**Job Name:** Land East of Lunce's Hill, Haywards Heath, West Sussex  
**Job No:** 332611520  
**Note No:** 001  
**Date:** September 2025  
**Prepared By:** B Haydon  
**Reviewed By:** N Fern  
**Subject:** Transport Addendum Note – in response to West Sussex County Council Highways and West Sussex County Council Waste  
**Planning Reference:** DM/25/0827

## 2. Response to WSCC Highways Comments

Drawing No. 332611520-SHA-XX-CR-C-0100

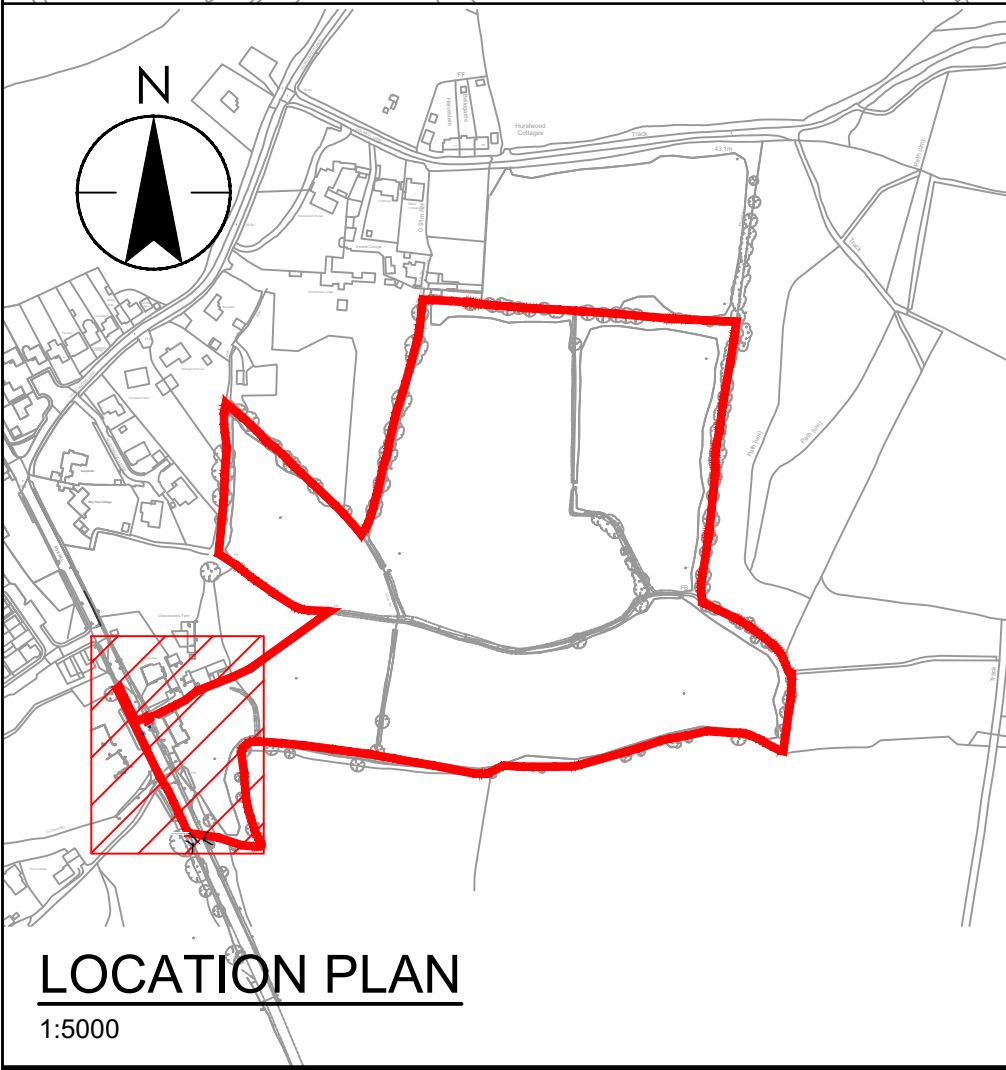
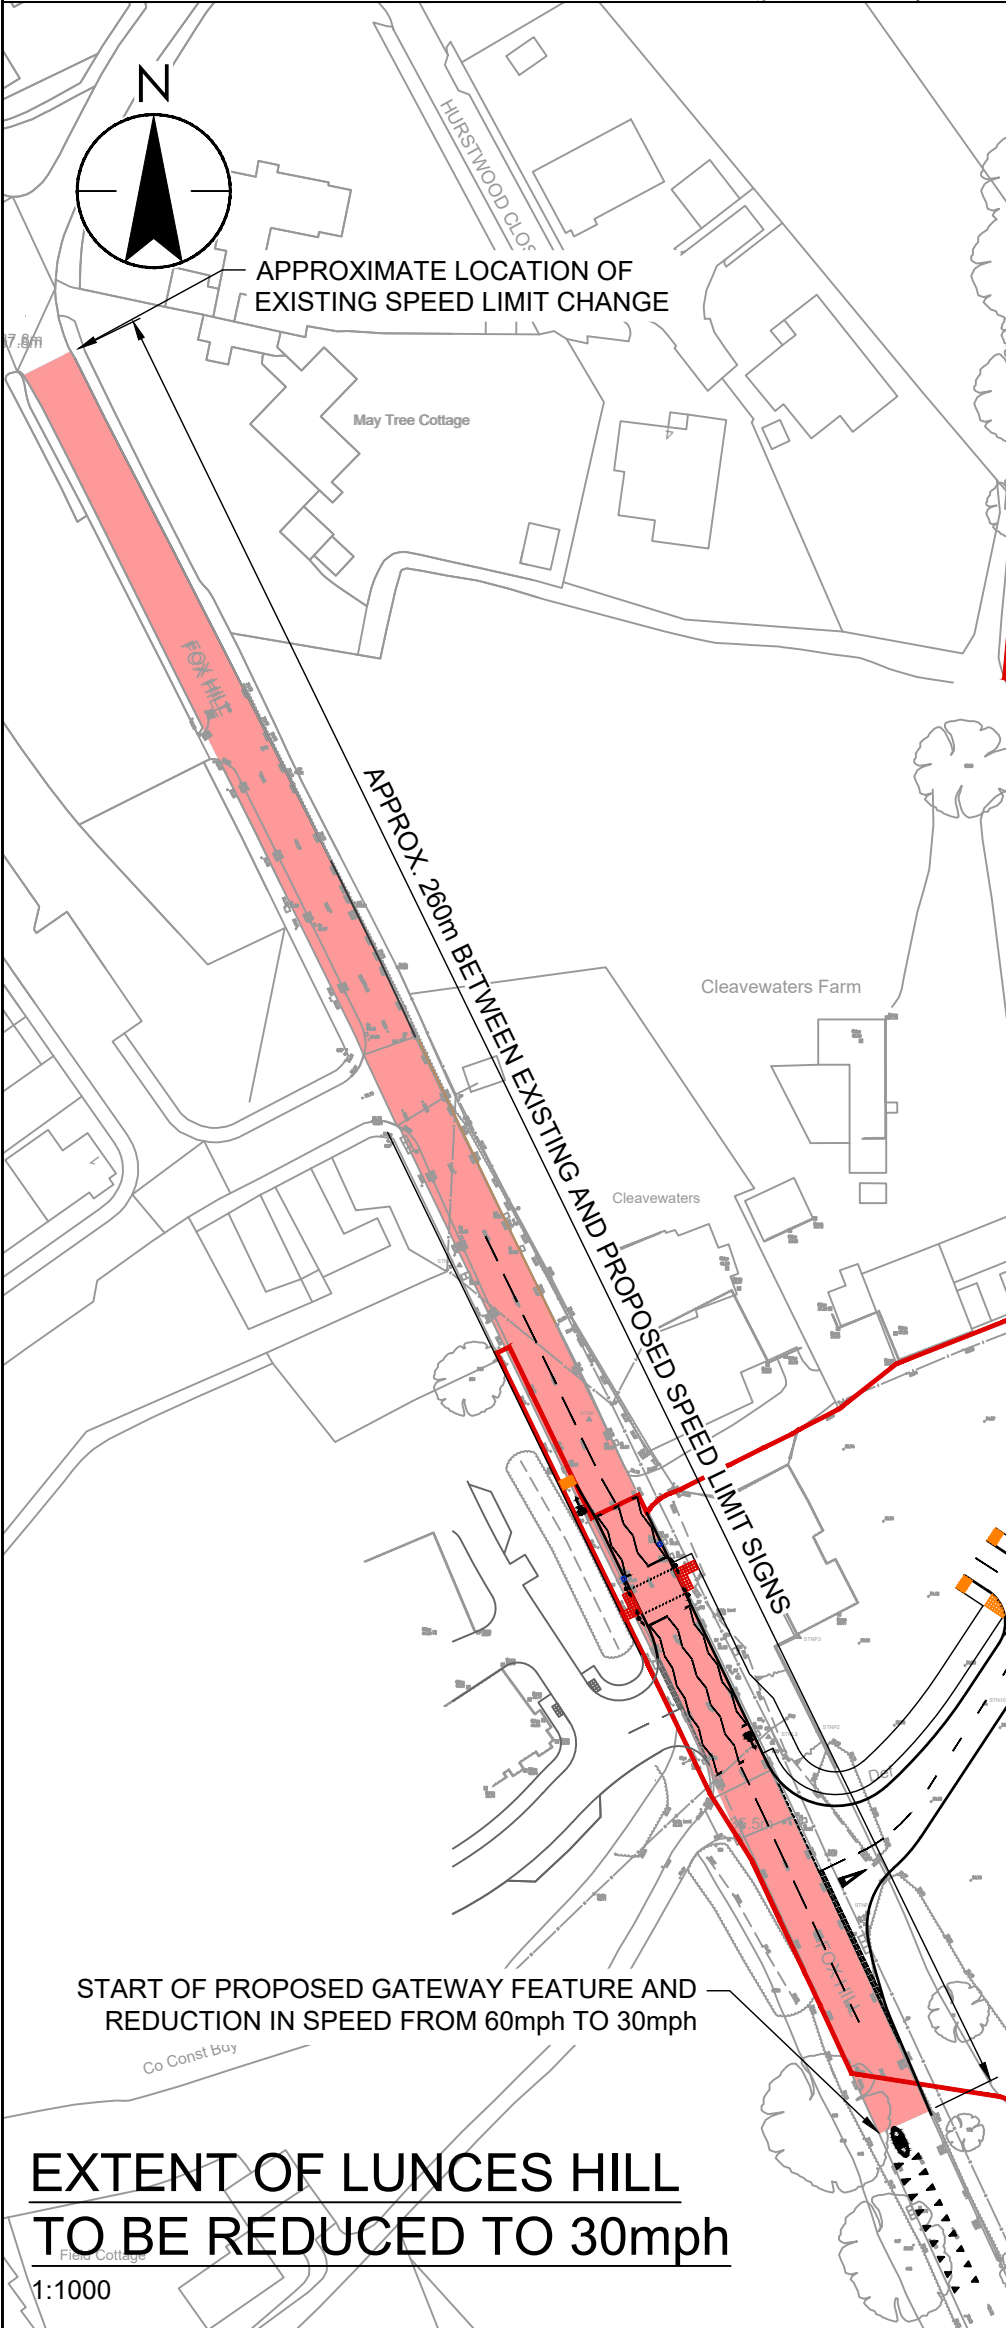
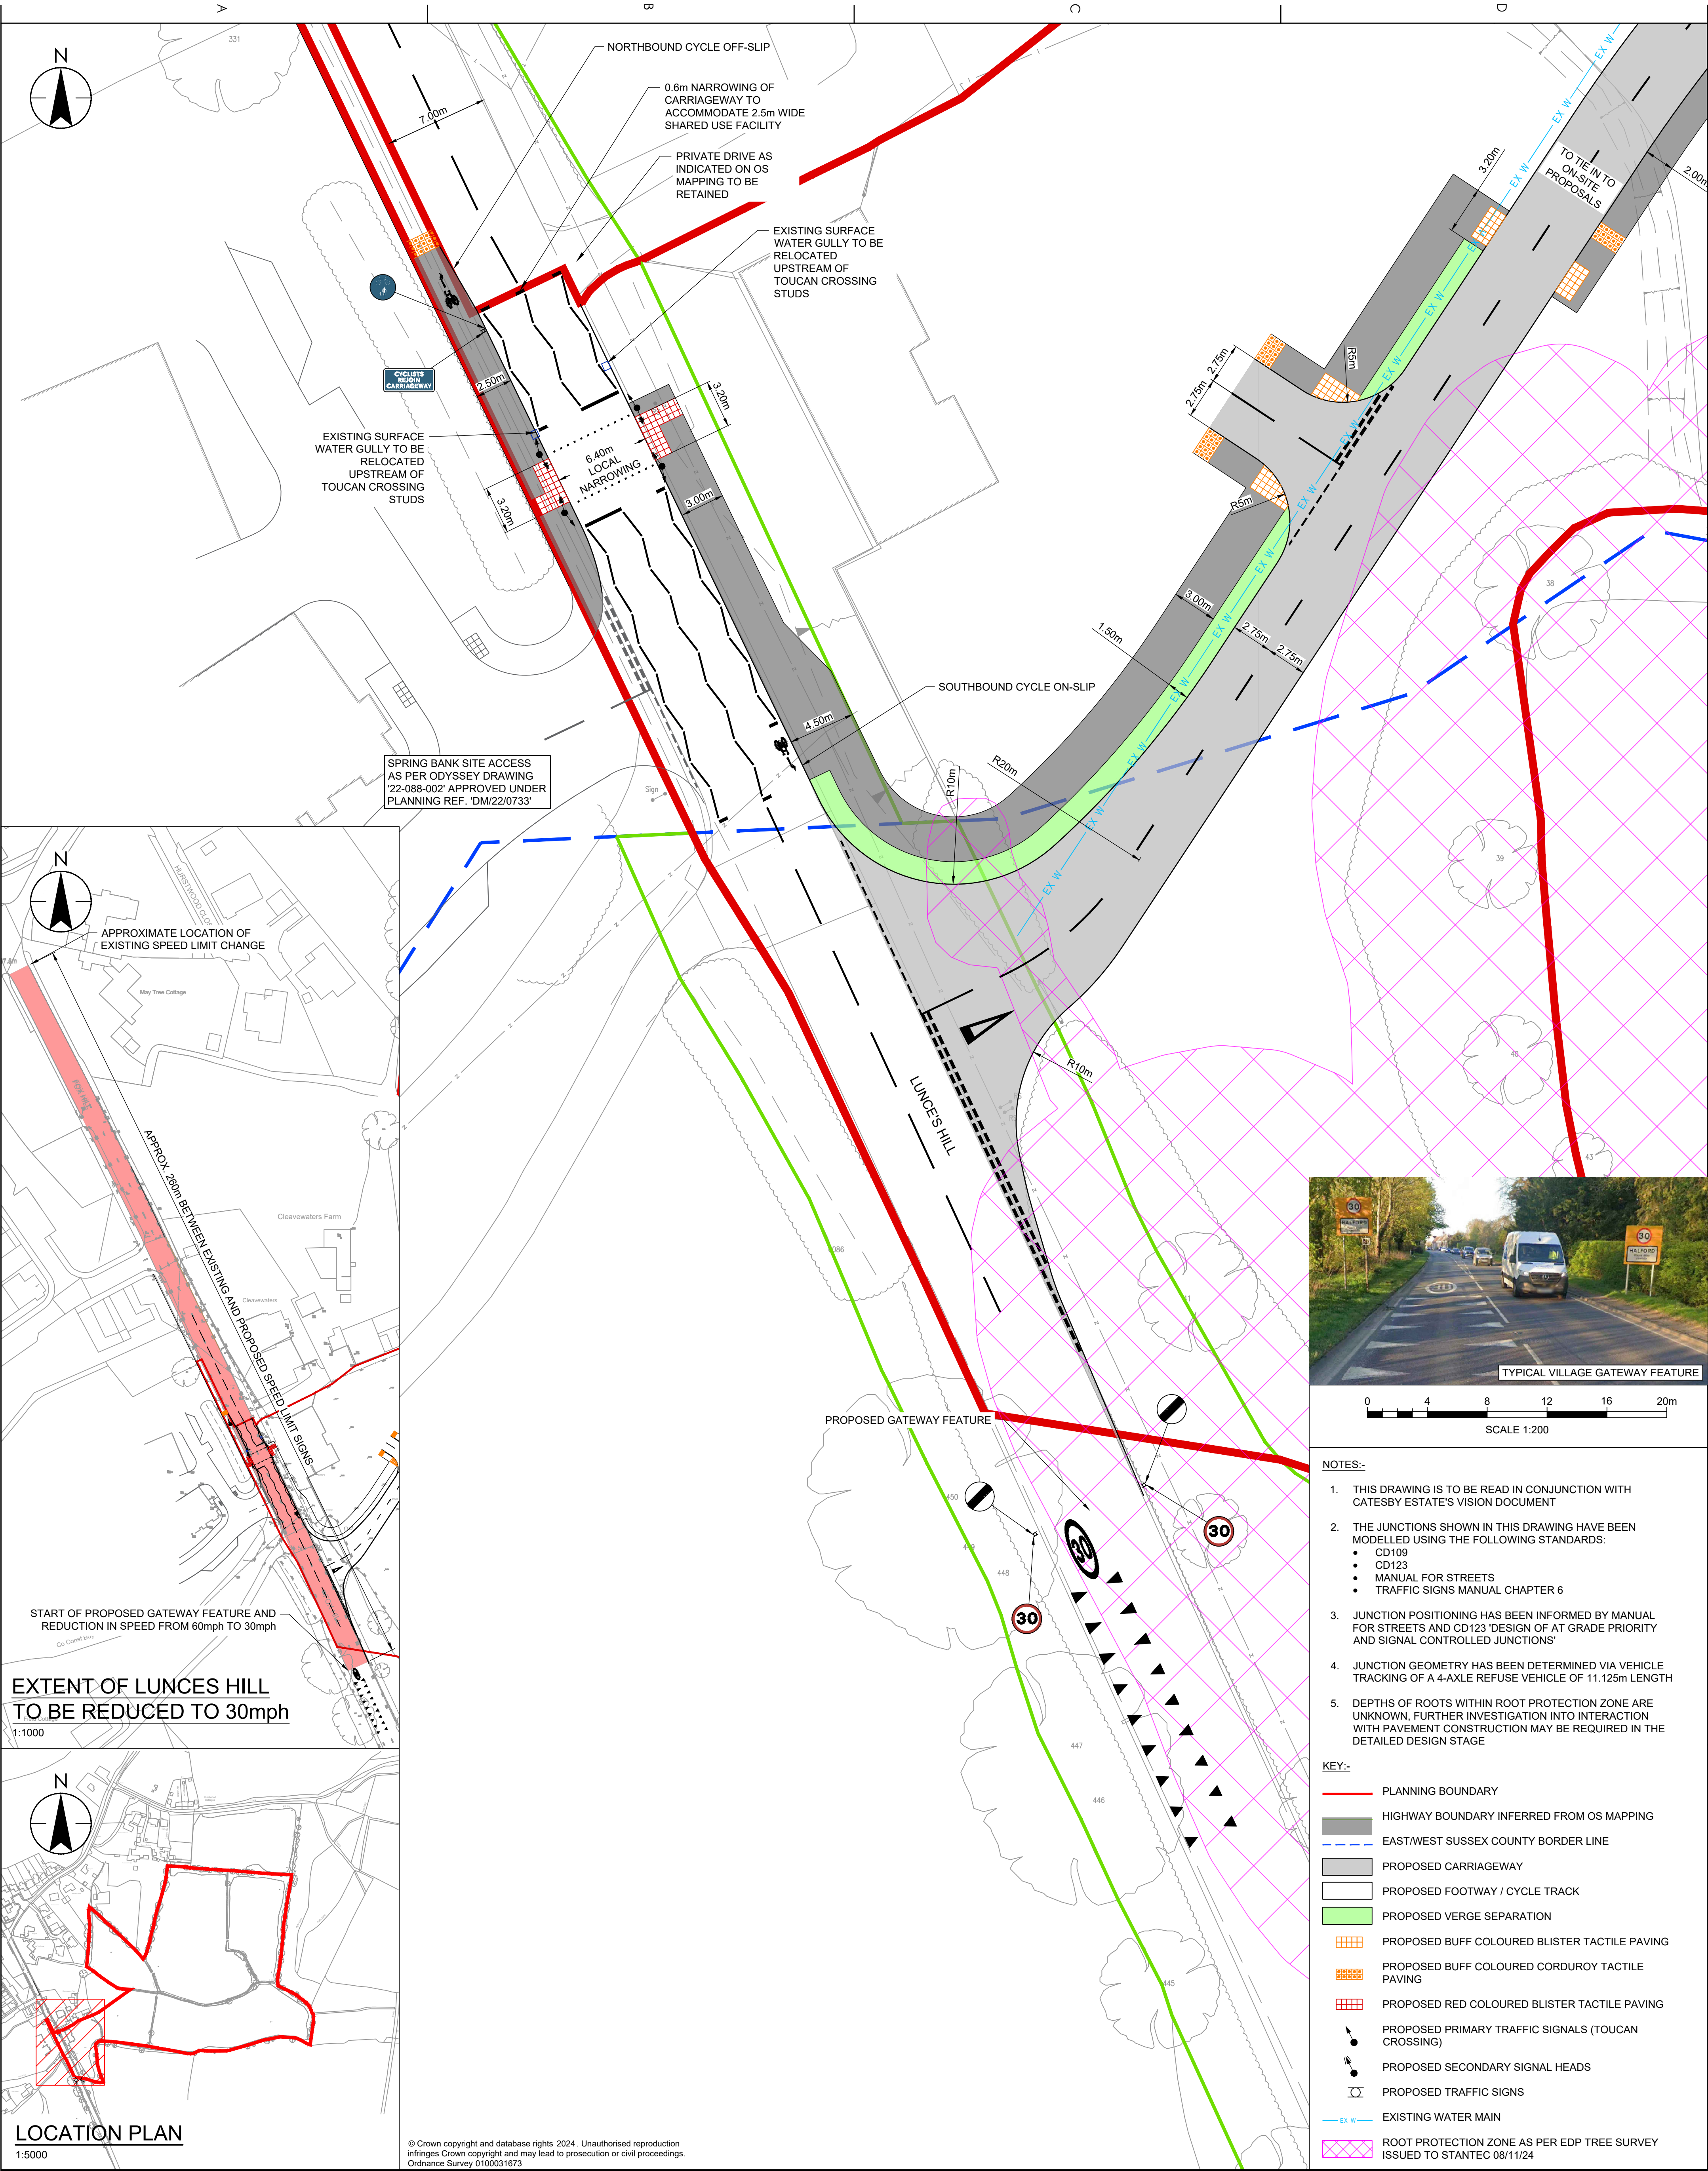
*"Because of the presence of the proposed puffin crossing, the speed limit will need to be reduced. As such, the applicant will need to show the extent of any revised (reduced) speed limit along Fox Hill (B2112) and how the extent promoted would meet the requirements of the WSCC Speed Limit Policy."*

*"With regards the detail of what is shown so far, concern is expressed regarding the proposal to encourage northbound cyclists to rejoin the carriageway on the opposite side to the southbound side. The signing on the plan does not appear to be correct. If the design is to remain largely as-is, it would require cyclists to dismount and then cross before continuing on the carriageway in northerly direction. The above should be looked at again."*

- 2.3. Stantec has provided two site access drawings:
  - i) Updated site access drawing based on the current speed limit;
  - ii) Additional site access drawing based on extending the 30mph speed limit to just south of the proposed site access including speed reducing measures, should WSCC agree to a speed limit extension.

2.21. WSCC Highways comments on cyclist provision has been noted, and further amendments have been made including changing the proposed controlled crossing to a toucan crossing.

2.22. The updated site access drawing is provided in **Appendix A**.
